## Product Update Memo

INDUCTIVE COMPONENTS

### Data Sheet Correction to Solder Terminal Dimension for SRP1265(A) Shielded Power Inductor Series

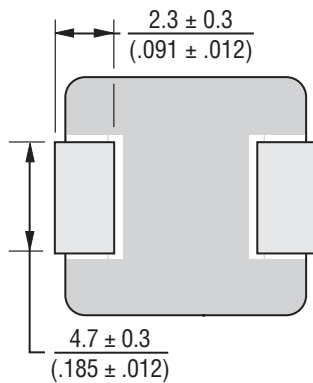
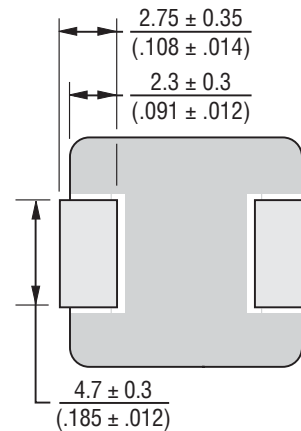
Recently, an error has been discovered in the solder terminal dimension of the [Model SRP1265\(A\)](#) data sheet drawings. The erroneous dimension (*Figure 1*) has been corrected (*Figure 2*).

The solder terminals of these two series have been manufactured to the *Figure 2* dimension since the inception of these inductors. This data sheet correction for Model SRP1265(A) has no impact to the form, fit, function and quality of the components.
